November 14, 2014

**BOARD OF COUNTY COMMISSIONERS
ORANGE COUNTY, FLORIDA
ADDENDUM NO. 2 / IFB Y15-721-EZ**

**ORANGE COUNTY CLARCONA HORSEMEN'S PARK KITCHEN AND REC BUILDING HVAC
REPLACEMENT**

100% CONSTRUCTION DOCUMENTS
Drawing No.
AD100

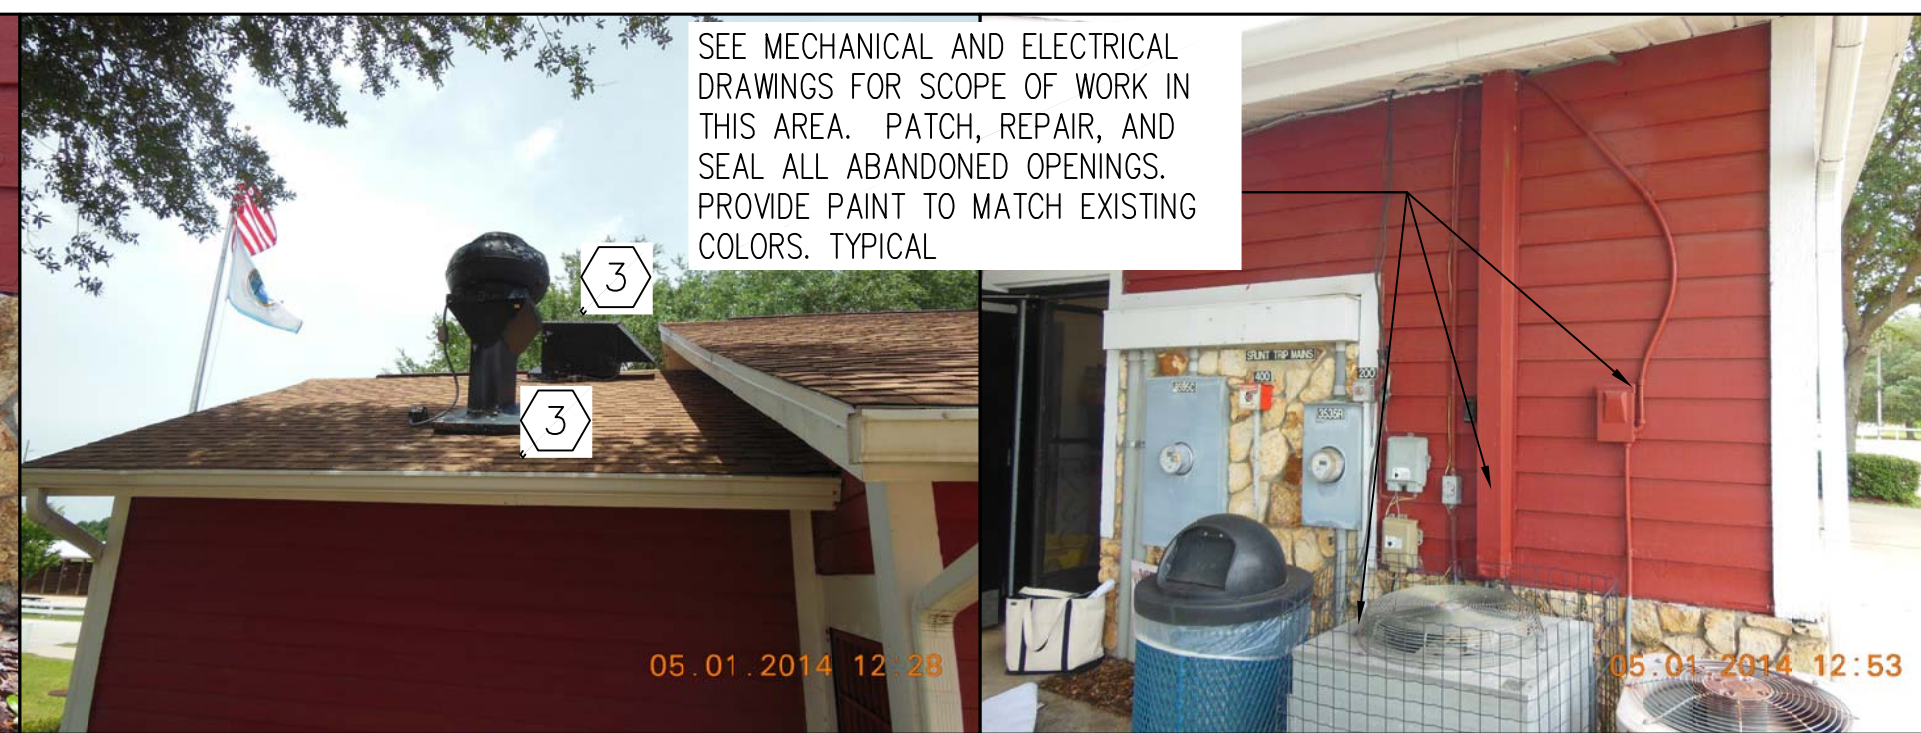
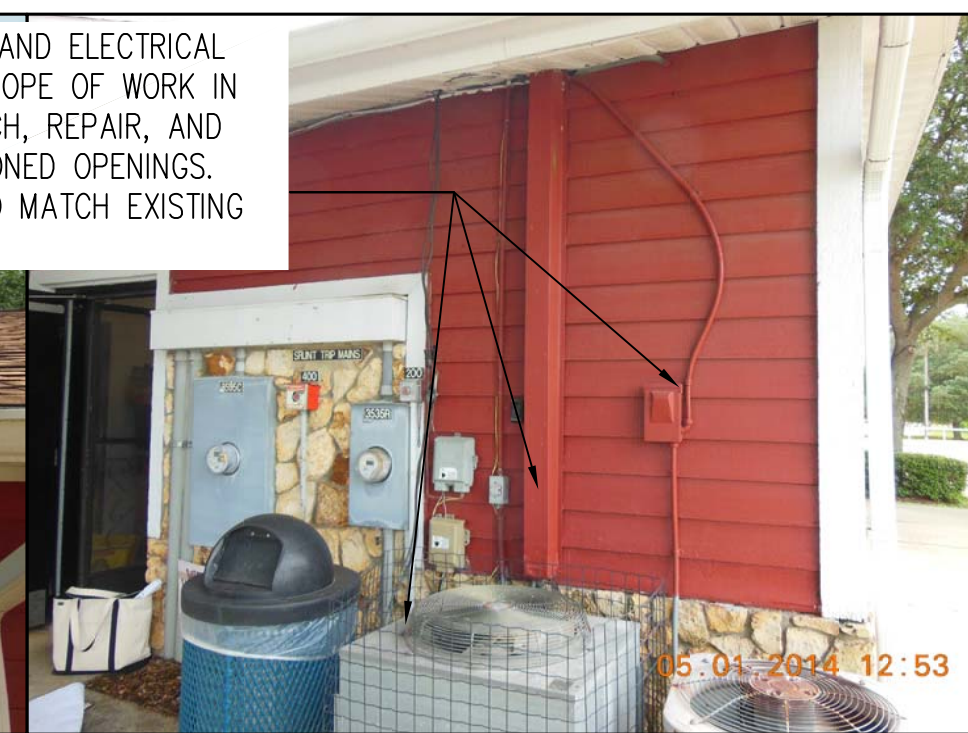
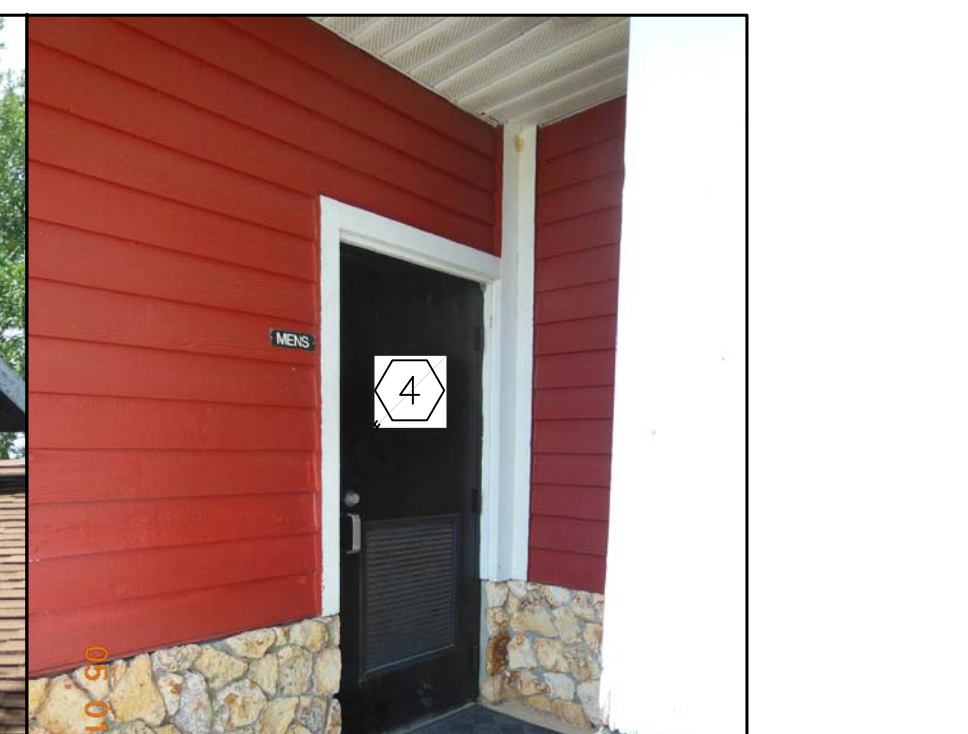
1. The following drawings, have been revised, with changes noted:
 - a. DRAWING SHEET NO. AD100 – PHOTOS OF EXISTING CONDITIONS
 - (1) Revise photos and hex notes to remove restroom scope from the project.

FLOOR PLAN DEMOLITION ARCHITECTURAL

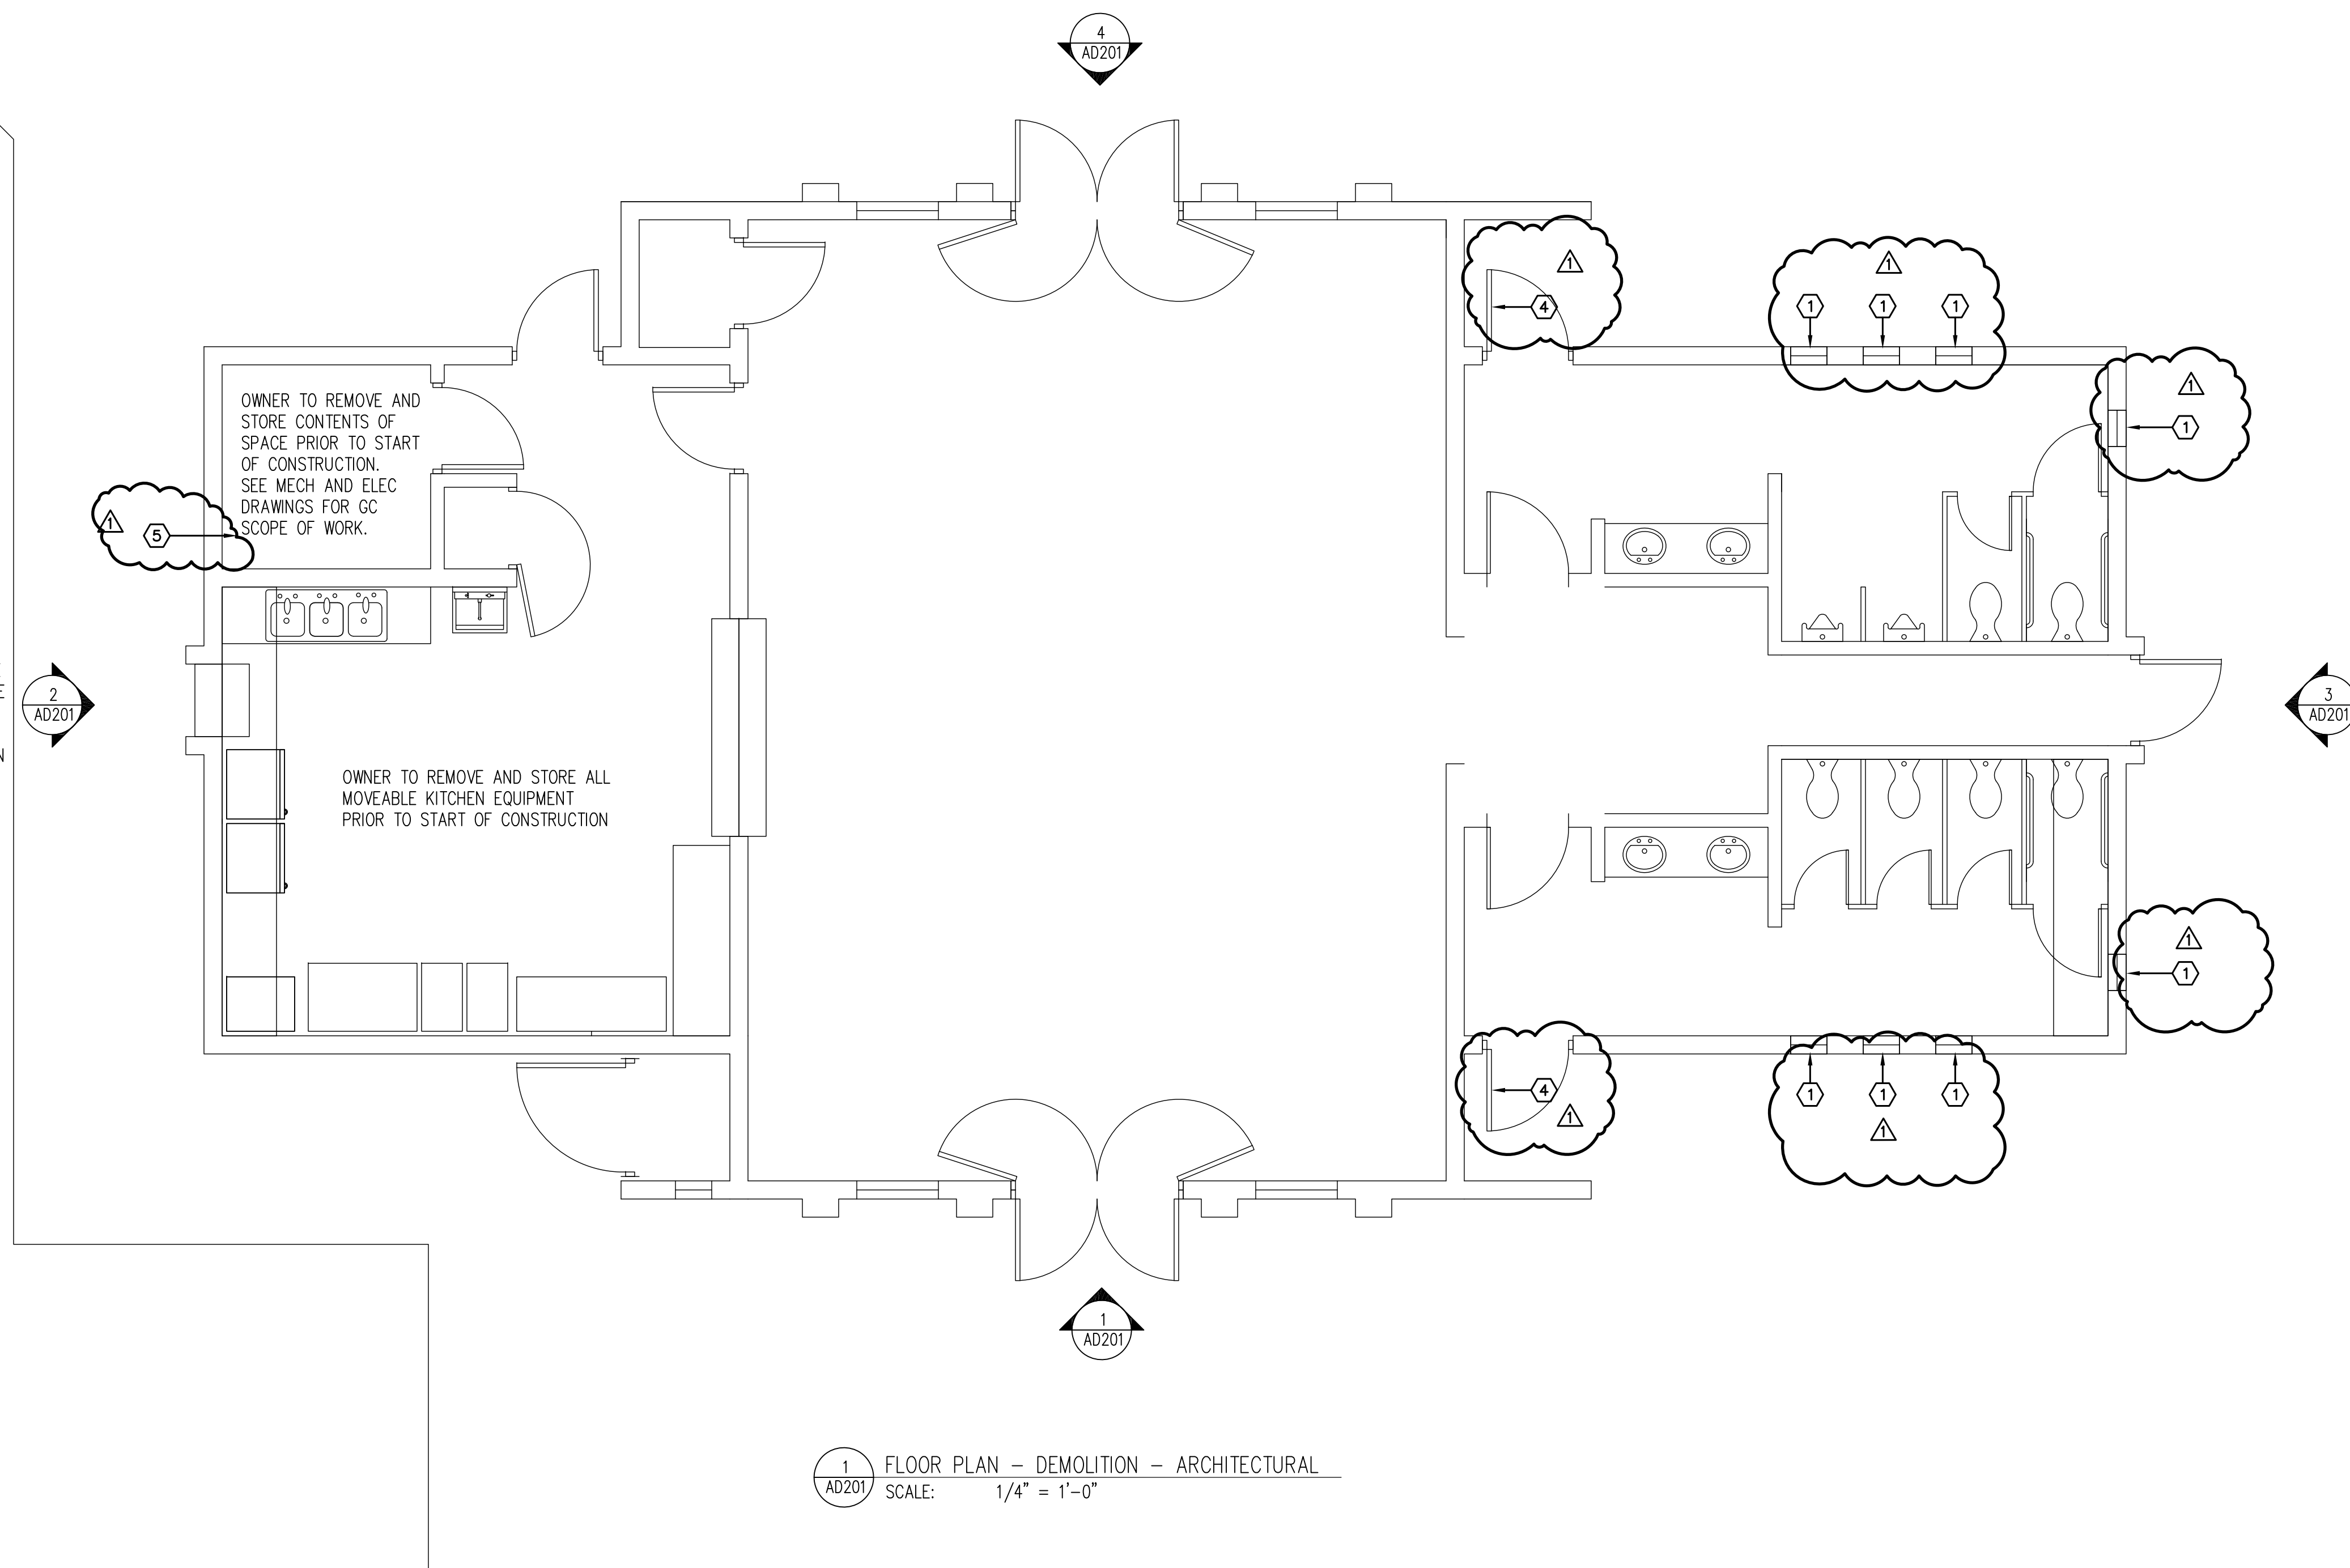
- b. DRAWING SHEET NO. AD101 – FLOOR PLAN – DEMOLITION - ARCHITECTURAL
 - (1) Revise Hex Notes 1, 4, and 5.
 - c. DRAWING SHEET NO. AD102 – REFLECTED CEILING PLAN – DEMOLITION – ARCHITECTURAL

Drawing Title:
REFLECTED CEILING PLAN DEMOLITION ARCHITECTURAL
100% CONSTRUCTION DOCUMENTS
Drawing No.
AD102

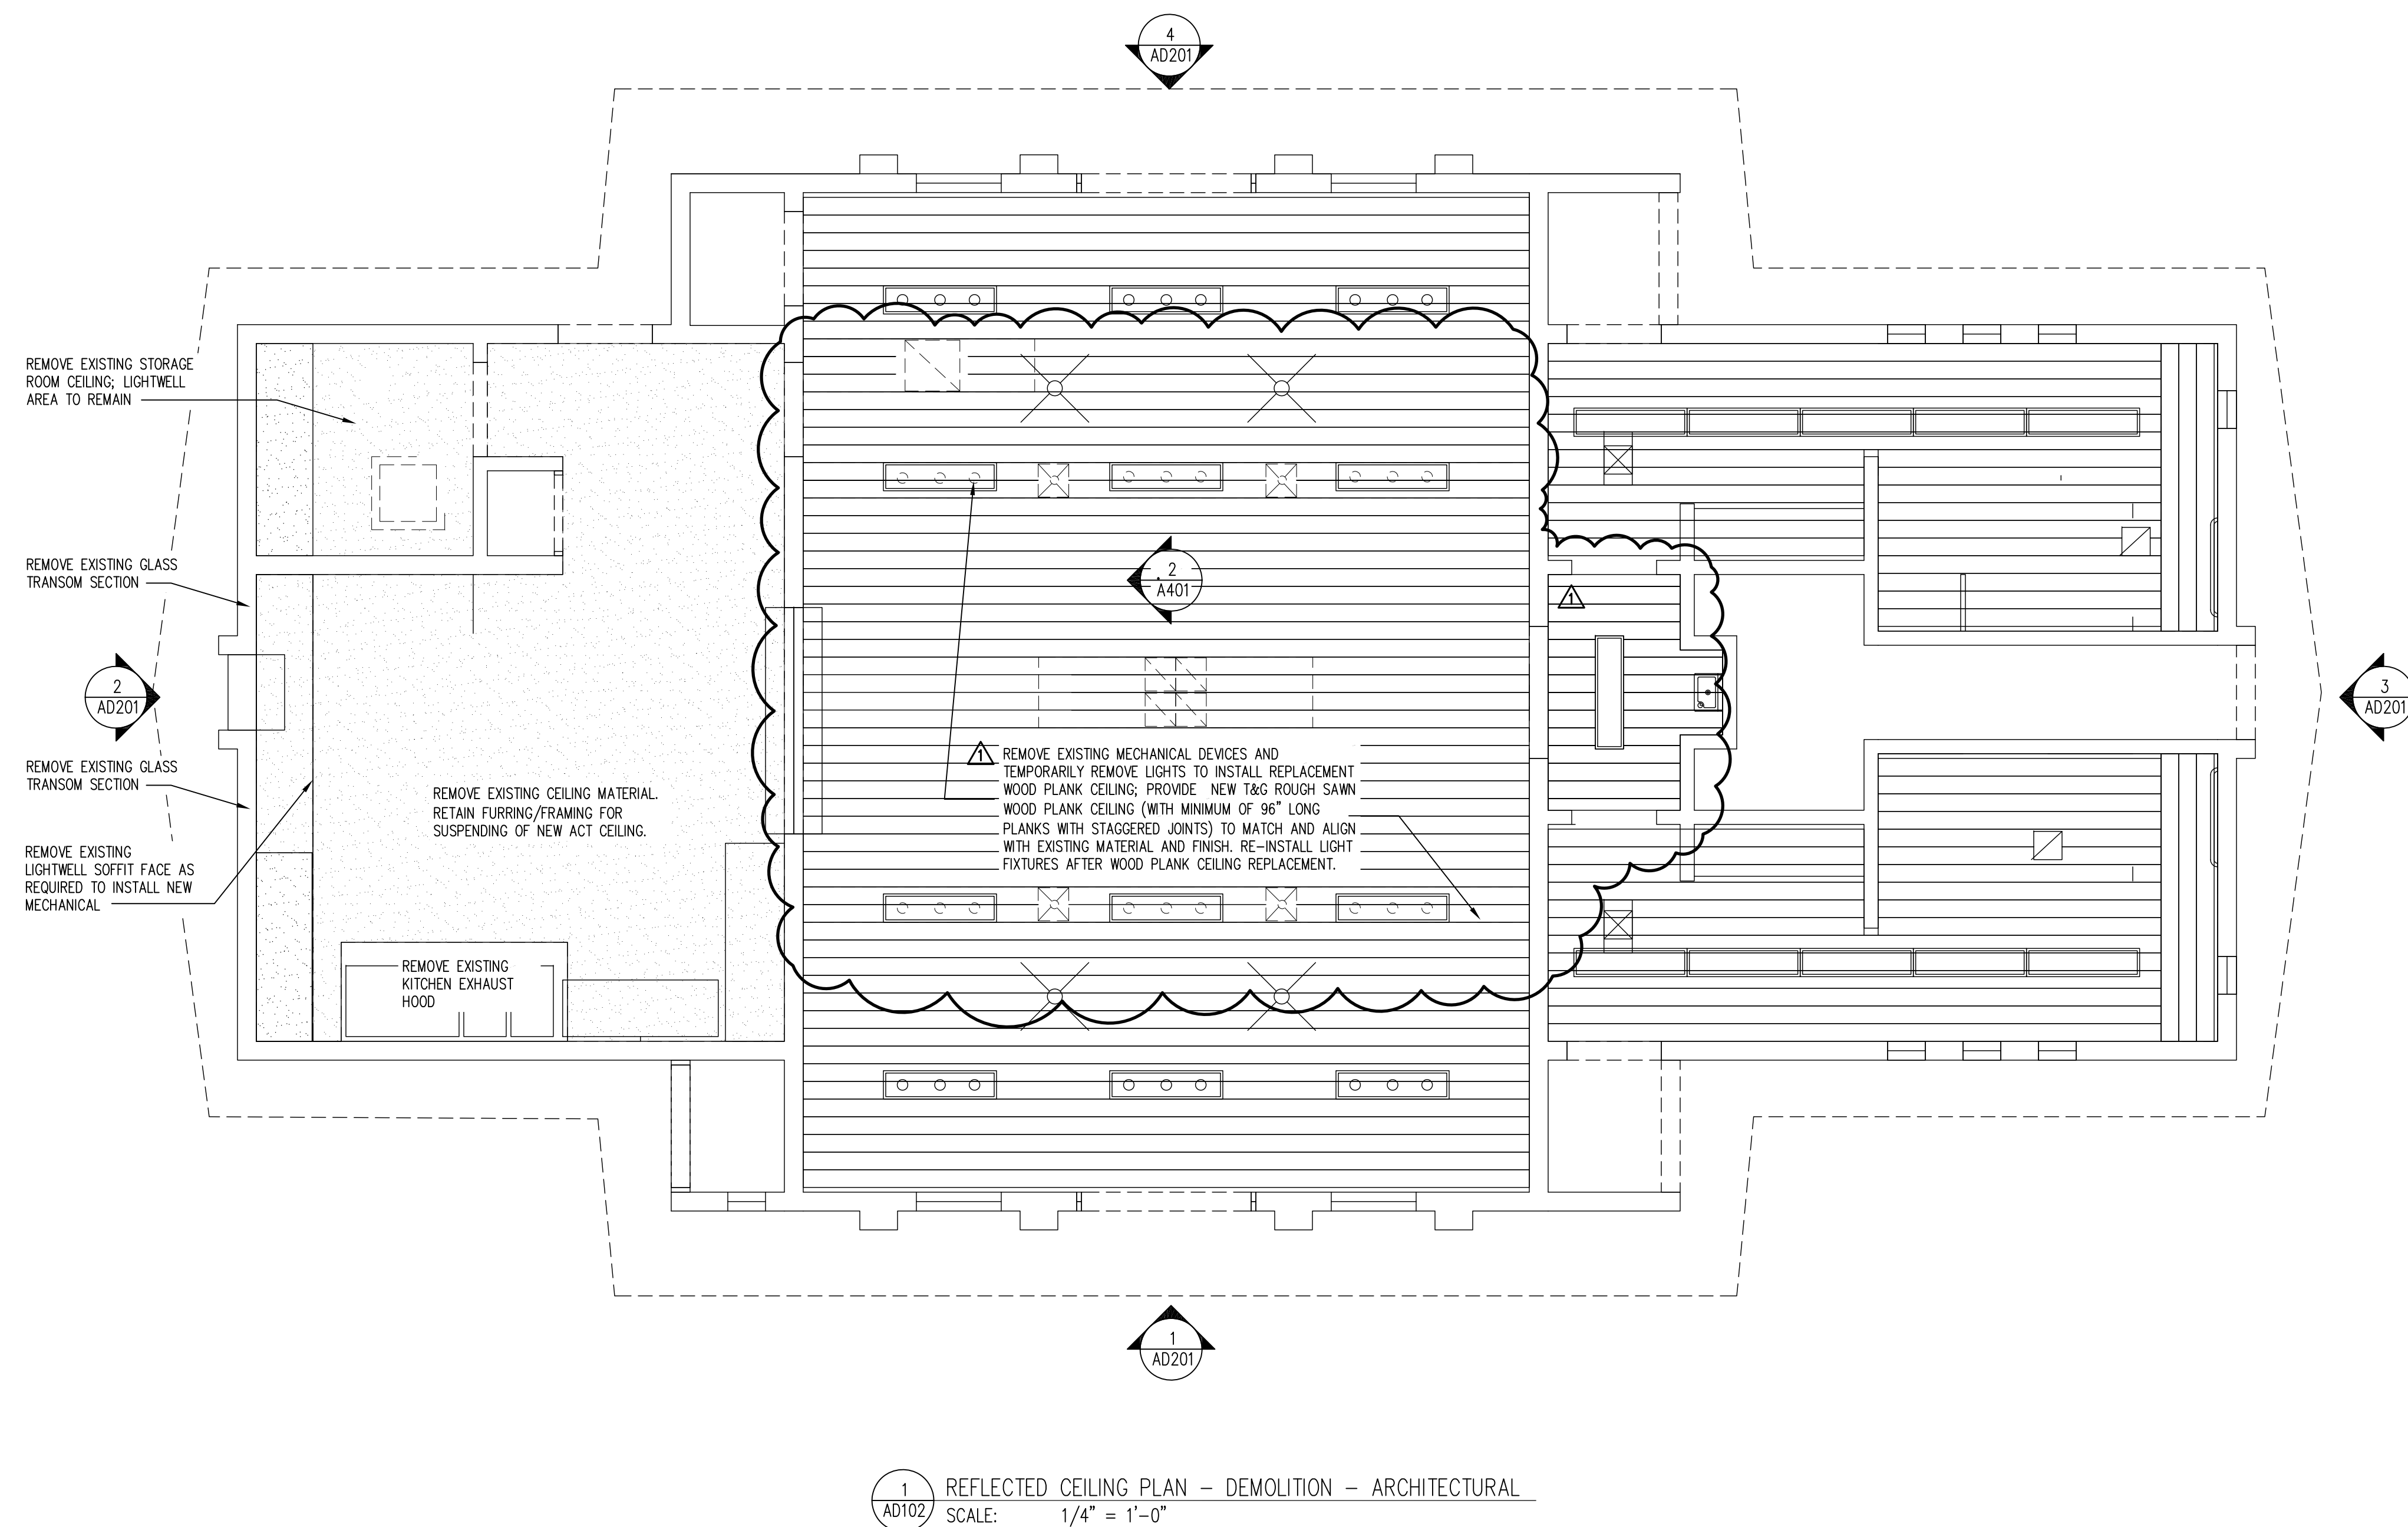
- (1) Revise Hex Notes 1, 4, and 5.
 - (2) Revise notes for demolition of existing ceiling devices.
 - d. DRAWING SHEET NO. AD201 – EXTERIOR ELEVATIONS - DEMOLITION
